PCN N° 2022-001-A

Capacity extension and harmonization of mould compound for dedicated OptiMOS™ products in PG-TDSON-8 package at Tongfu Microelectronics Co. Ltd China

Subject Capacity extension and harmonization of mould compound at Tongfu Microelectronics Co. Ltd. for PG-TDSON-8 package

Comparison of Marking on Device

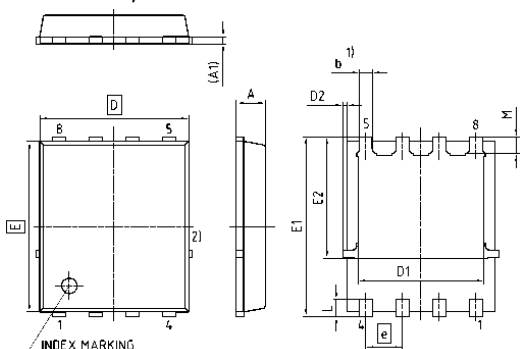
Old	New
Assembly and final test location	<ul style="list-style-type: none"> Infineon Technologies Malaysia Sdn. Bhd., Melaka Subcontractor ATX (Weihai) Inc., China Infineon Technologies Wuxi Co., Ltd., China Subcontractor Tongfu Microelectronics Co. Ltd., China 	<ul style="list-style-type: none"> Infineon Technologies Malaysia Sdn. Bhd., Melaka Subcontractor ATX (Weihai) Inc., China Infineon Technologies Wuxi Co., Ltd., China Subcontractor Tongfu Microelectronics Co. Ltd., China
Marking on Device	<ul style="list-style-type: none"> Infineon Technologies Malaysia Sdn. Bhd., Melaka Subcontractor ATX (Weihai) Inc., China Infineon Technologies Wuxi Co., Ltd., China Subcontractor Tongfu Microelectronics Co. Ltd., China (partially)* 	<ul style="list-style-type: none"> Infineon Technologies Malaysia Sdn. Bhd., Melaka Subcontractor ATX (Weihai) Inc., China Infineon Technologies Wuxi Co., Ltd., China Subcontractor Tongfu Microelectronics Co. Ltd., China

Package Outline Drawing Comparison

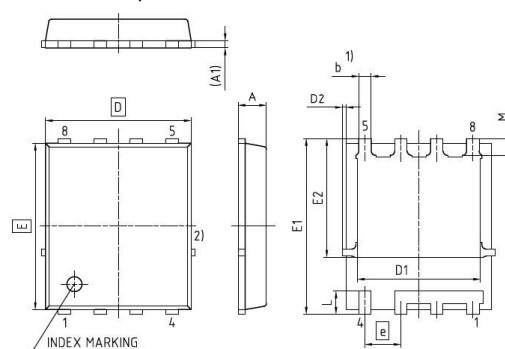
Update of package outline drawing in the datasheet (3_cip22001_a)

SYMBOL	Non fused lead				SYMBOL	Fused lead			
	TDSON-8 (old) [mm]		TDSON-8 (new) [mm]			TDSON-8 (old) [mm]		TDSON-8 (new) [mm]	
	Issue: 11/01/2017 Rev: 06		Issue: 06/06/2019 Rev: 07			Issue: 02/08/2011 Rev: 01		Issue: 19/06/2019 Rev: 03	
	MIN	MAX	MIN	MAX		MIN	MAX	MIN	MAX
A	0.90	1.10	0.90	1.20	A	0.90	1.10	0.90	1.20
A1	0.15	0.35	0.15	0.35	A1	0.15	0.35	0.15	0.35
b	0.31	0.54	0.34	0.54	b	0.34	0.54	0.34	0.54
D	4.95	5.35	4.80	5.35	D	4.95	5.35	4.80	5.35
D1	3.70	4.40	3.90	4.40	D1	3.70	4.40	3.70	4.40
D2	0.02	0.22	0.03	0.23	D2	0.02	0.22	0.02	0.23
E	5.70	6.10	5.70	6.10	E	5.90	6.10	5.70	6.10
E1	5.95	6.35	5.90	6.42	E1	6.05	6.25	5.90	6.42
E2	3.81	4.31	3.88	4.31	E2	3.81	4.31	3.88	4.42
e	1.27		1.27		e	1.27		1.27	
L	0.45	0.71	0.45	0.71	L	0.74	0.84	0.69	0.90
M	0.45	0.75	0.45	0.69	M	0.45	0.66	0.45	0.69
